STATE OF VERMONT AGENCY OF TRANSPORTATION

PROPOSED IMPROVEMENT TOWN OF PERU COUNTY OF BENNINGTON VT ROUTE 11 (MINOR ARTERIAL)

Record Plans

DIRECTOR OF PROJECT DELIVERY	APPROVED DATE 12/31/2014
PROJECT MANAGER : KEN UPMAL, P.E.	
PROJECT NAME : PERU	
PROJECT NUMBER : STP SCR(4)	
SHEET 1 OF 45 SHEETS

GALVANIZED STEEL CHANNEL  
 NOT TO SCALE

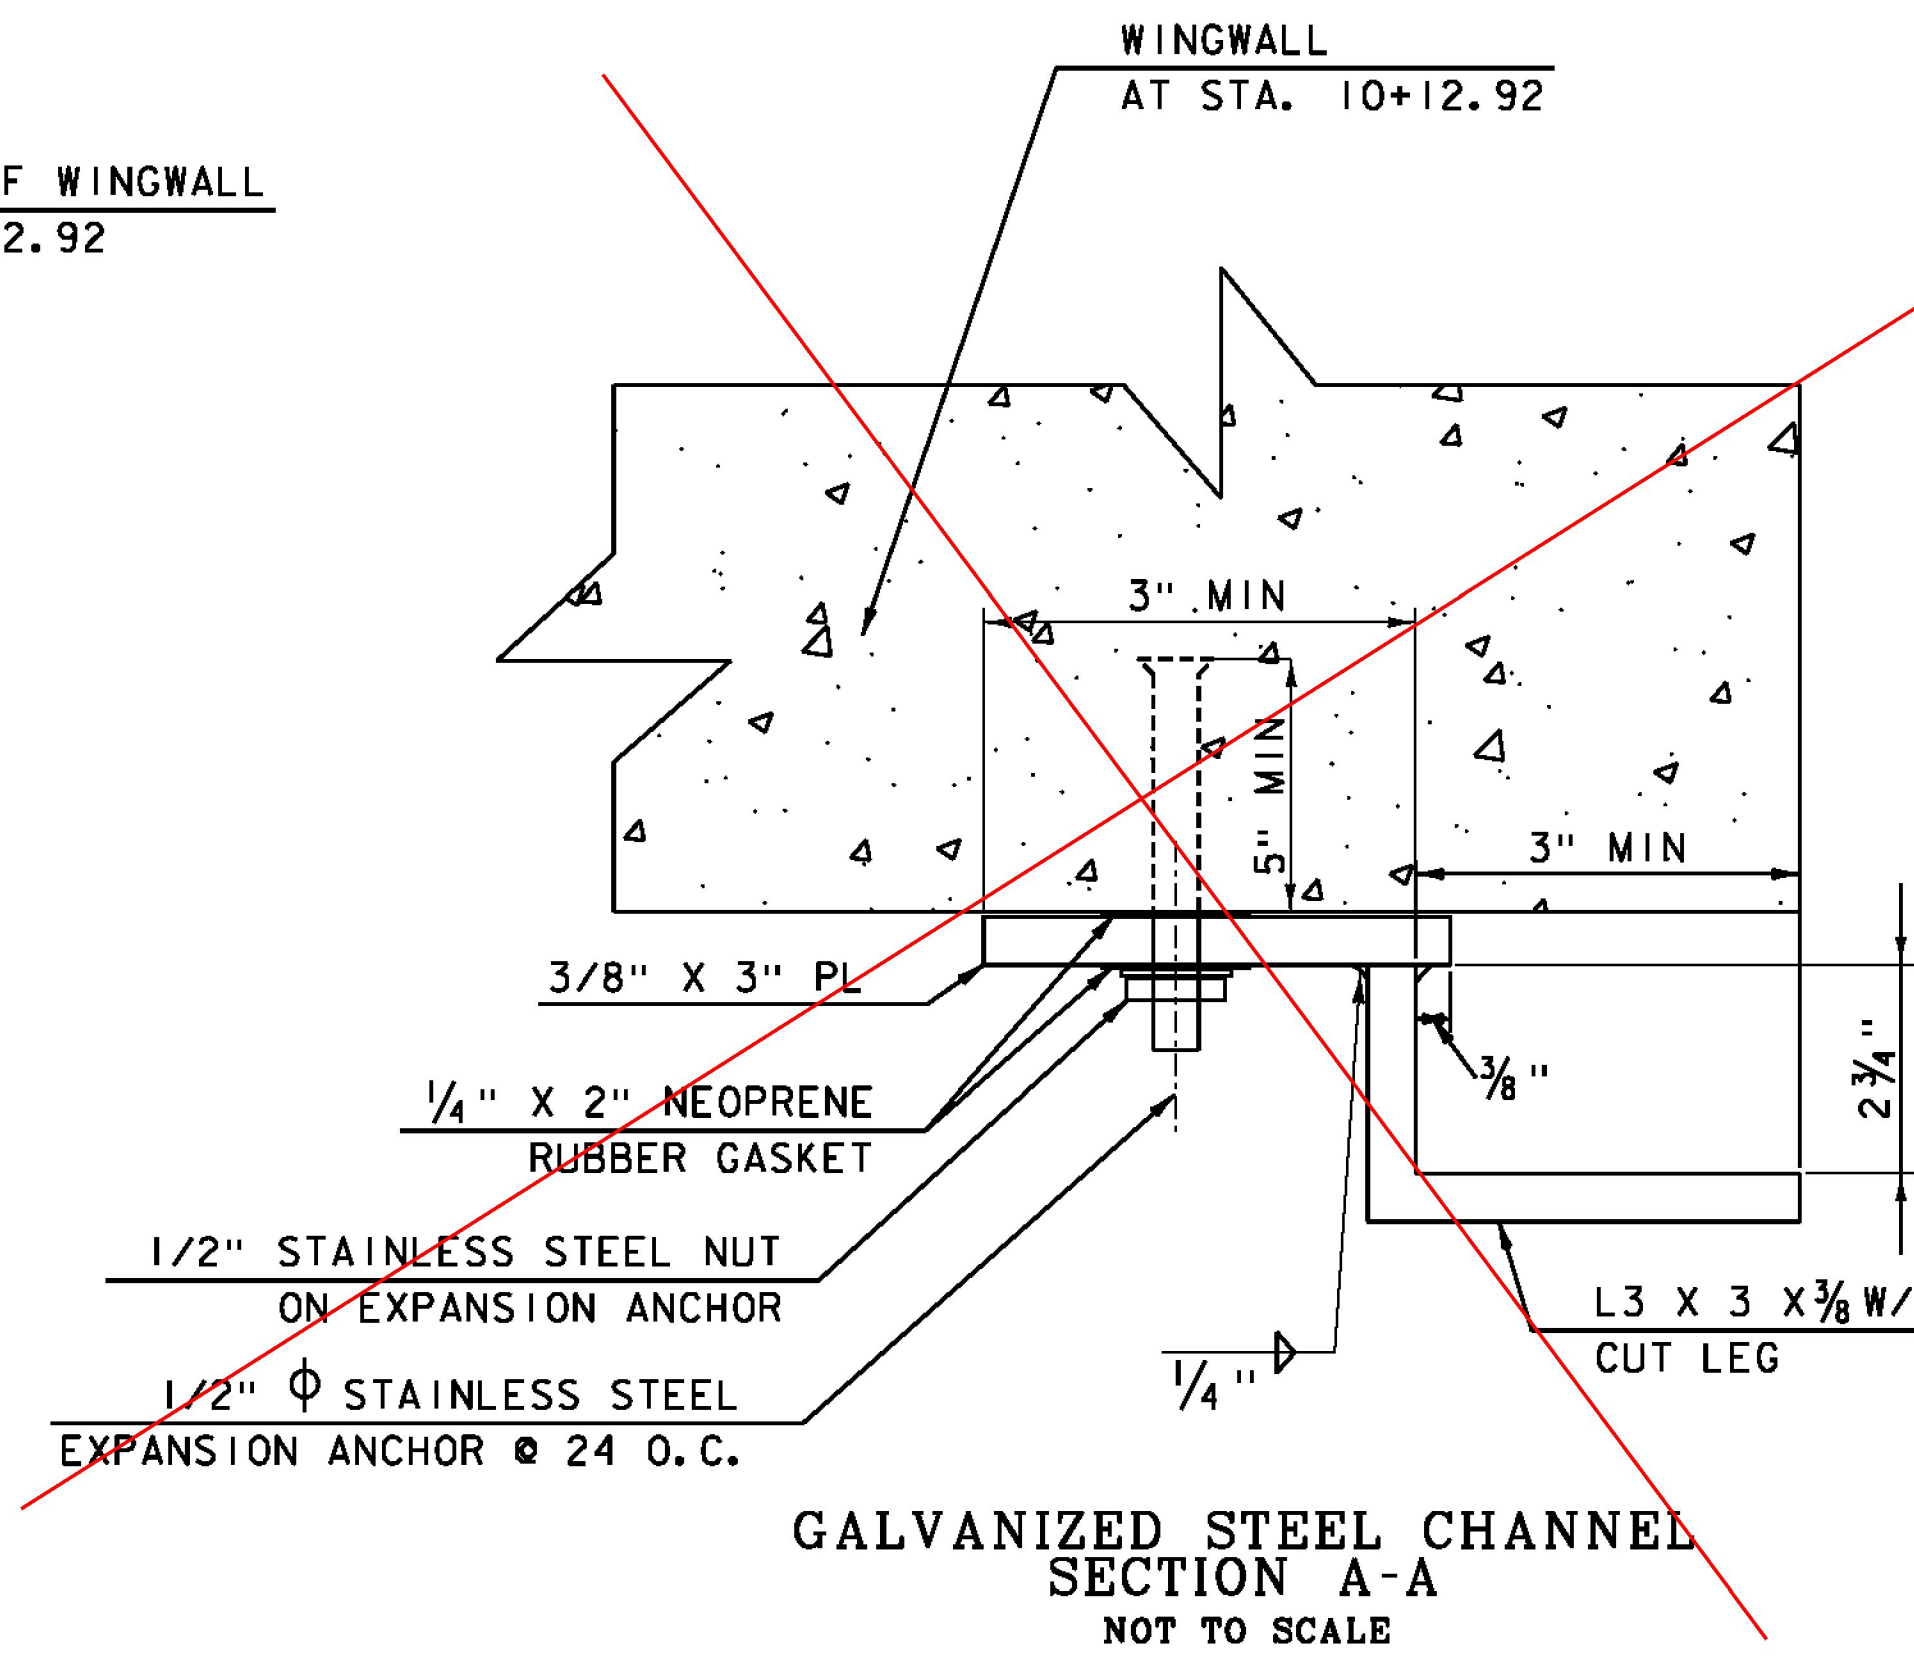
**NOTE:**  
 STOP LOG SYSTEM INITIALLY INSTALLED; DUE TO FAILURE,  
 SYSTEM WAS REPLACED IN JUNE 2018 WITH A SLUICE GATE.  
 SEE FOLLOWING SHEETS FOR SLUICE GATE SYSTEM.

SHEET NAME: RAIL LAYOUT

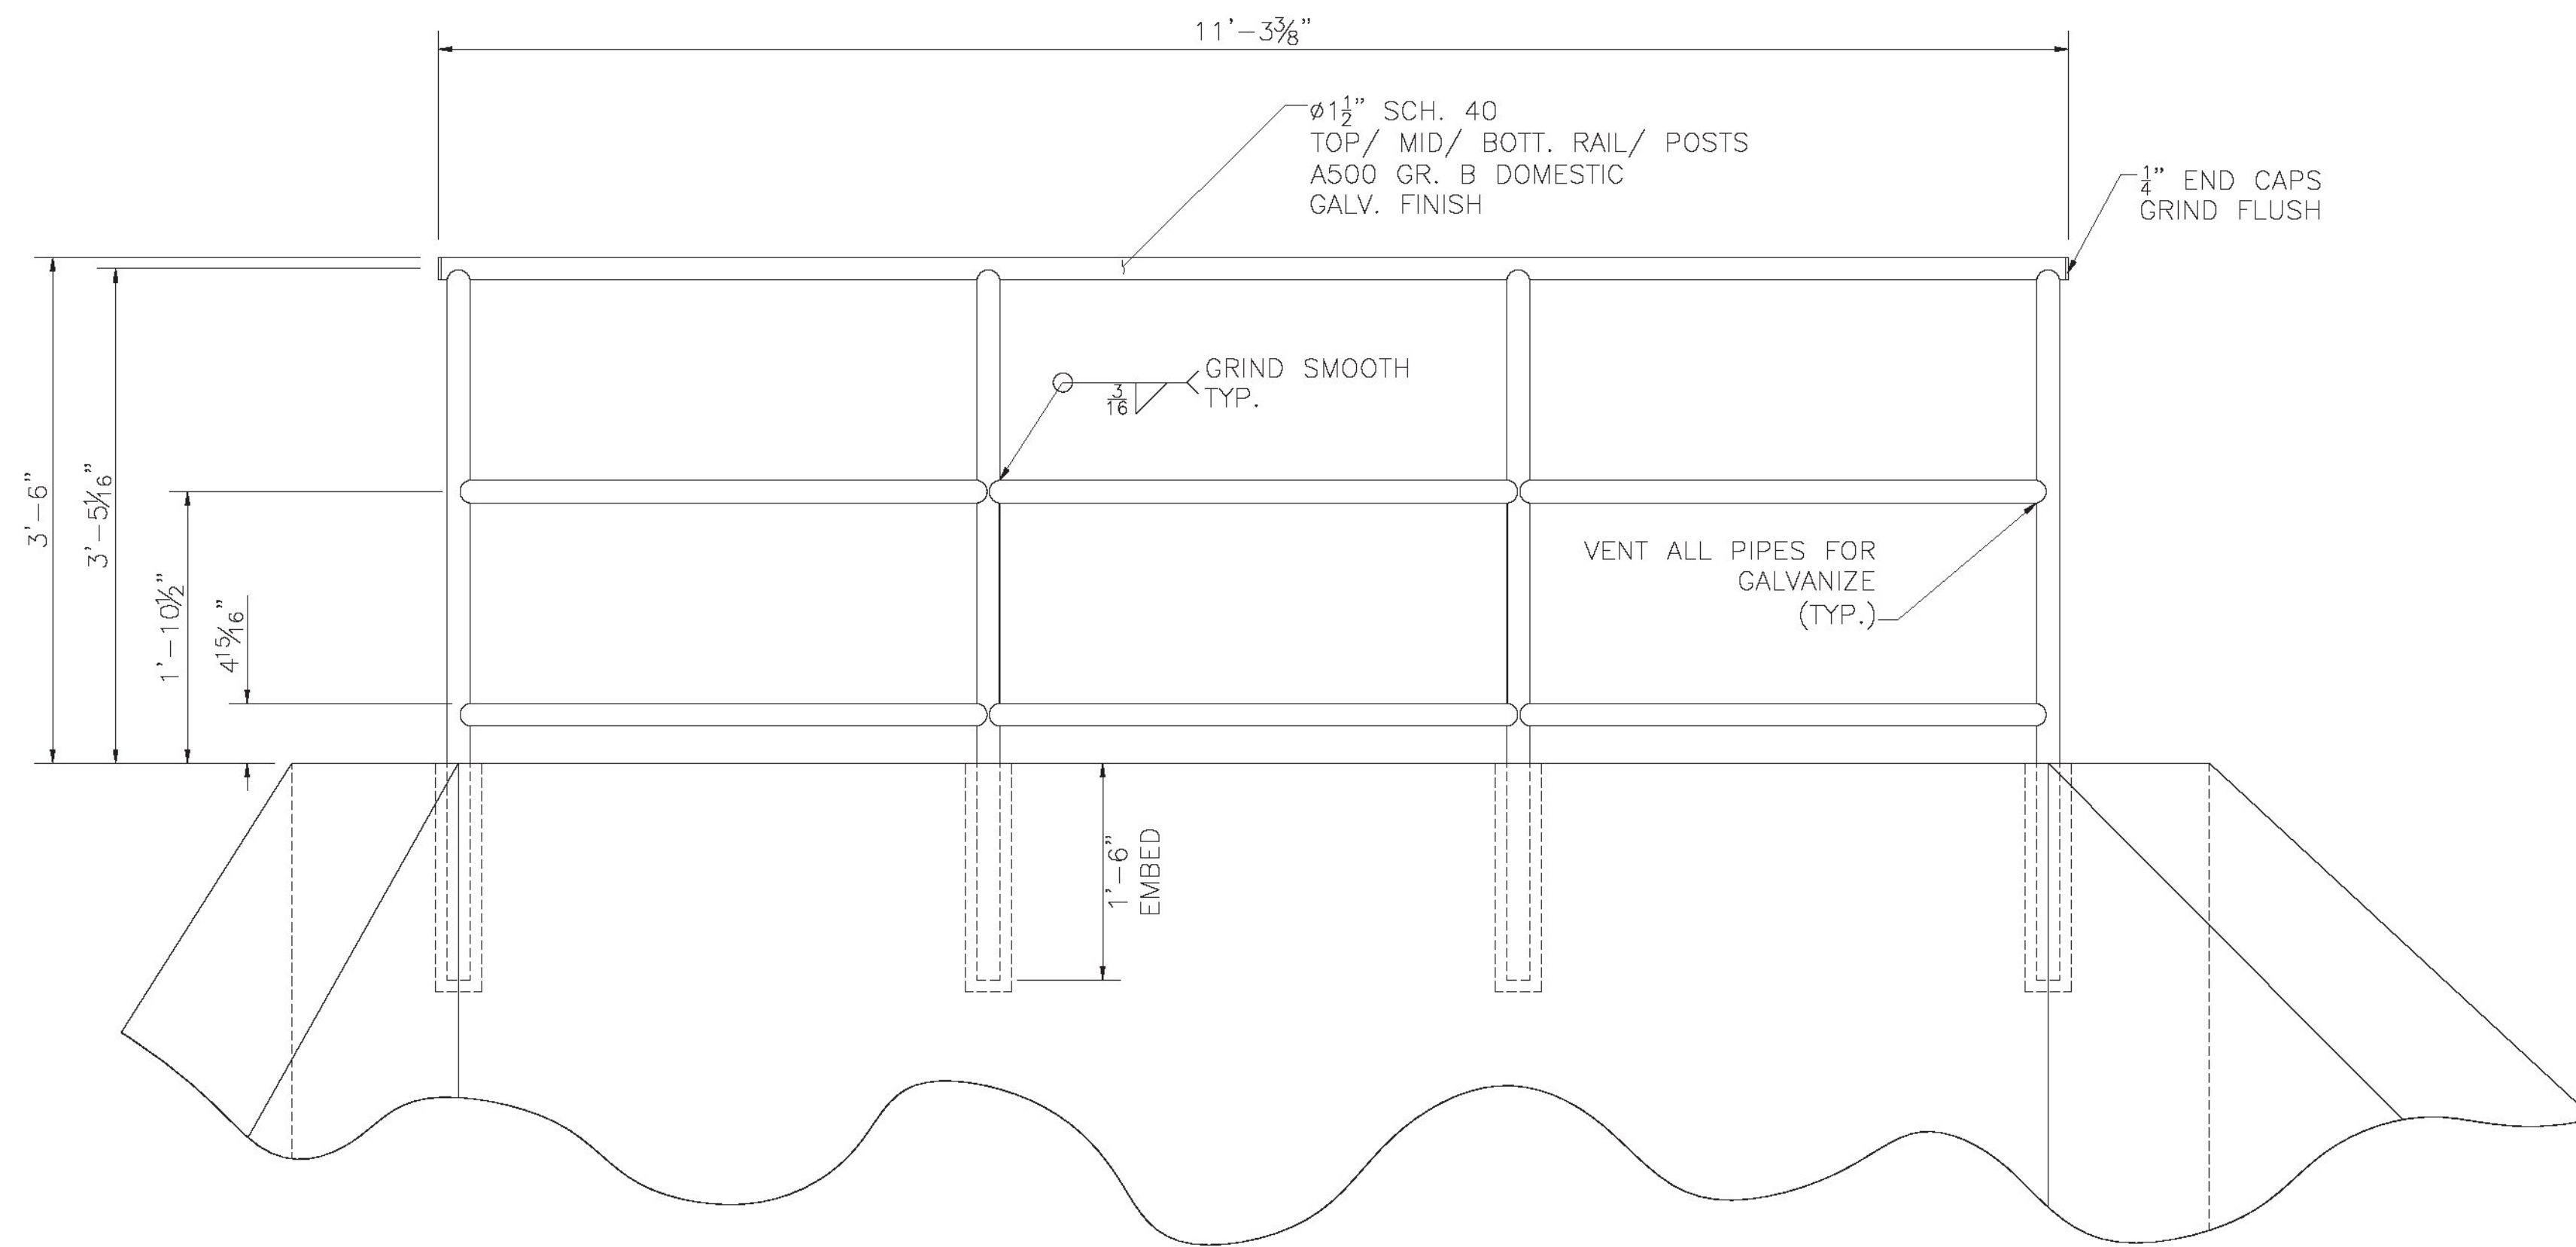
The calculation is not properly done and is difficult to understand. However, we performed our own independent analysis on the railings and posts and found that the 1 1/2" pipes are within the allowable stress limit and are acceptable.

<input checked="" type="checkbox"/>	NO EXCEPTIONS TAKEN
<input type="checkbox"/>	MAKE CORRECTIONS NOTED
<input type="checkbox"/>	REVISE AND RESUBMIT
<input type="checkbox"/>	REJECTED

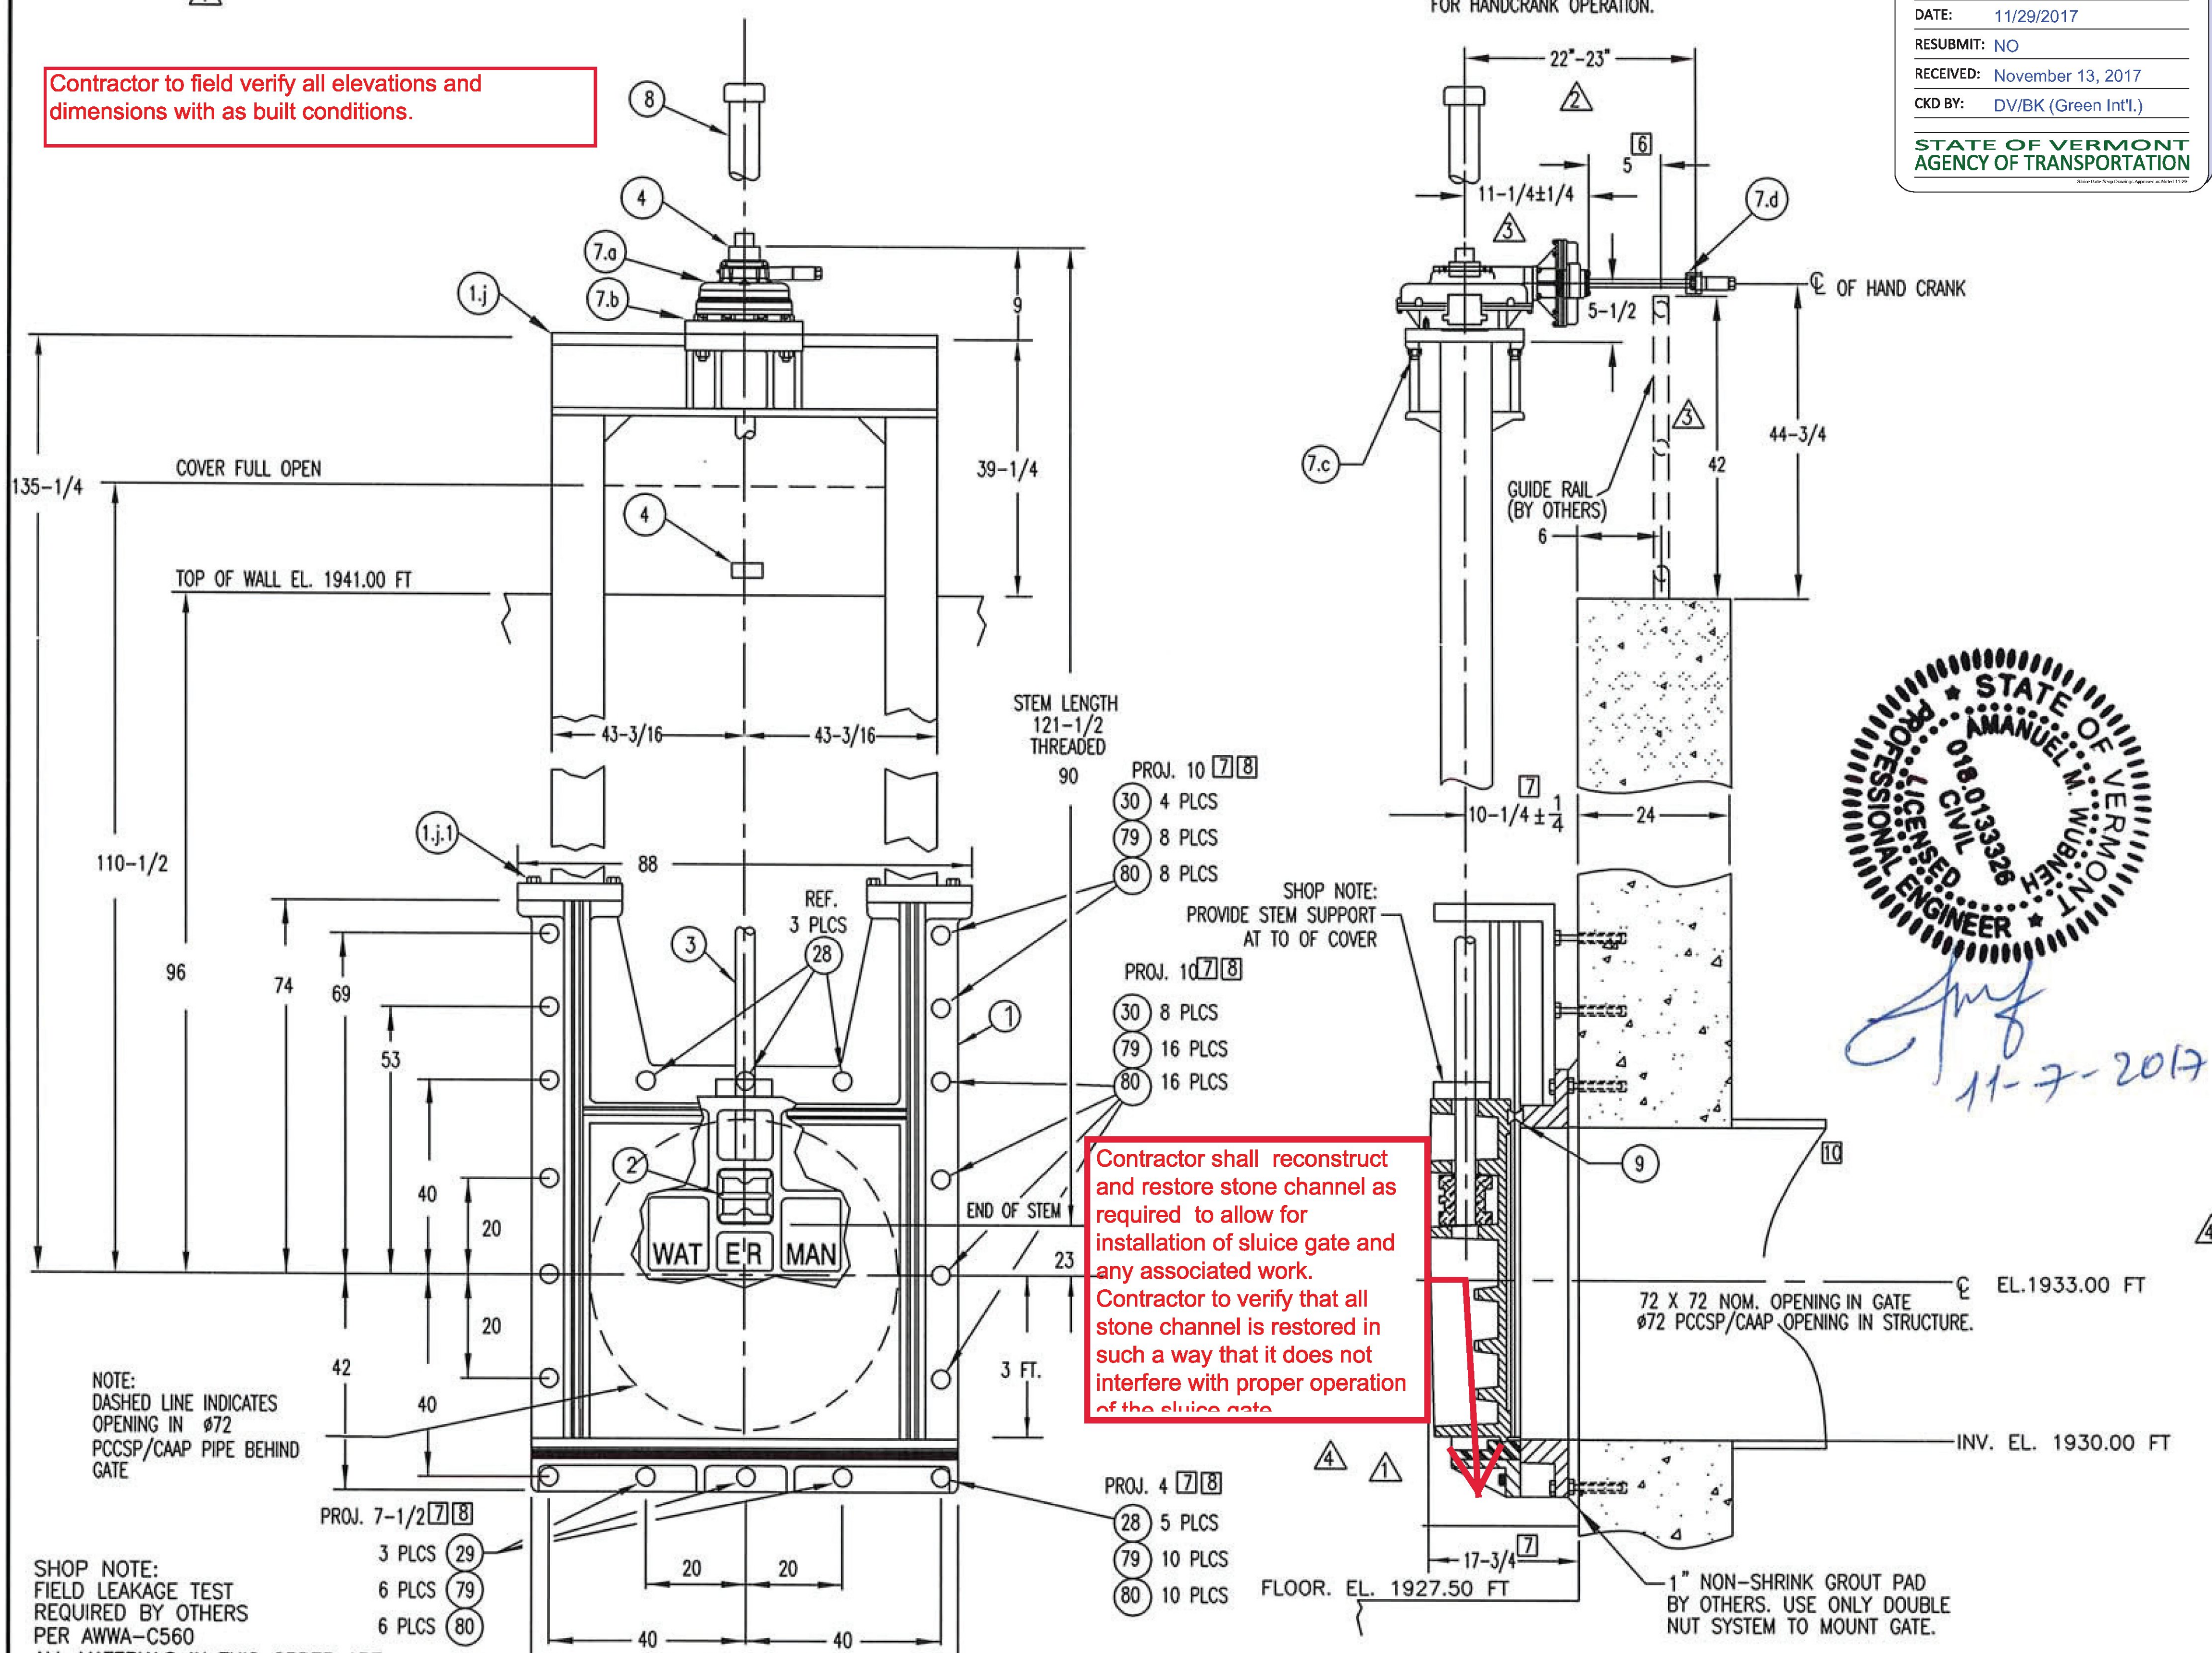
Contractor to field verify all elevations and dimensions with as built conditions.

Contractor shall reconstruct and restore stone channel as required to allow for installation of sluice gate and any associated work. Contractor to verify that all stone channel is restored in such a way that it does not interfere with proper operation of the sluice gate.

**Approved AsNoted**  
 BY: Ken Upmal  
 DATE: 11/29/2017  
 RESUBMIT: NO  
 RECEIVED: November 13, 2017  
 CKD BY: DV/BK (Green Intl.)  
 STATE OF VERMONT  
 AGENCY OF TRANSPORTATION
